# Access Compliance Report

## Public Rights-of-Way

### (Curb Ramps)

Intersection ID: 44943	Main Street: COLTART_CT	Cross Street: LARIMER_LN	Location:	E
ADA ID: 77605C60542B	Ramp Type: PerpDiag	Initial Pass/Fail: Fail	Overall Compliance: No	Severity Score: 42.5

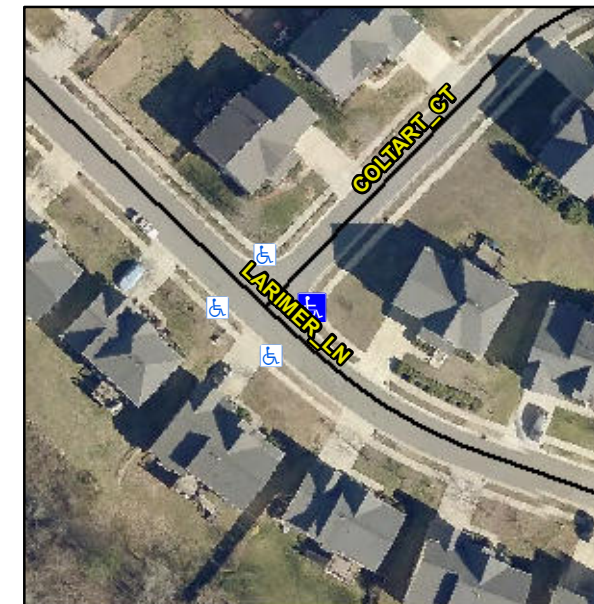
**Not Found, R304.5.1, R304.5.3**

Compliance	Description	Data	Compliance	Description	Data
N/A	Ramp Length (in)	49.0	Yes	Ramp Slope (%)	5.0
No	Ramp Width (in)	33.0	No	Ramp XSlope (%)	10.4
N/A	Flare Type LT	N/A	N/A	Flare Type RT	N/A
N/A	Flare Slope LT (%)	N/A	N/A	Flare Slope RT (%)	N/A
N/A	Flare Traversable LT?	N/A	N/A	Flare Traversable RT?	N/A
N/A	Landing Length (in)	N/A	N/A	DWS Provided?	N/A
N/A	Landing Width (in)	N/A	N/A	DWS Contrast?	N/A
N/A	Landing Slope (%)	N/A	N/A	DWS Length (in)	N/A
N/A	Landing X Slope (%)	N/A	N/A	DWS Full Width?	N/A
N/A	Landing Curb? (Y/N)	N/A	N/A	DWS Offset (in)	N/A
N/A	Shared Landing?	N/A			
N/A	Gutter Ponding?	N/A	N/A	Gutter Slope (%)	N/A
N/A	Gutter Lip Ht (in)	N/A	N/A	Gutter X Slope (%)	N/A
N/A	Painted X Walk1?	No	N/A	Painted X Walk2?	No
	X Walk 1 Direction	To NW		X Walk 2 Direction	To SW
N/A	X Walk 1 Width (in)	N/A	N/A	X Walk 2 Width (in)	N/A
	X Walk 1 Slope (%)	3.2		X Walk 2 Slope (%)	5.4
	X Walk 1 X Slope (%)	5.2		X Walk 2 X Slope (%)	4.9

**Remove & Replace Curb Ramp With Two New Directional Ramps or Equivalent.**
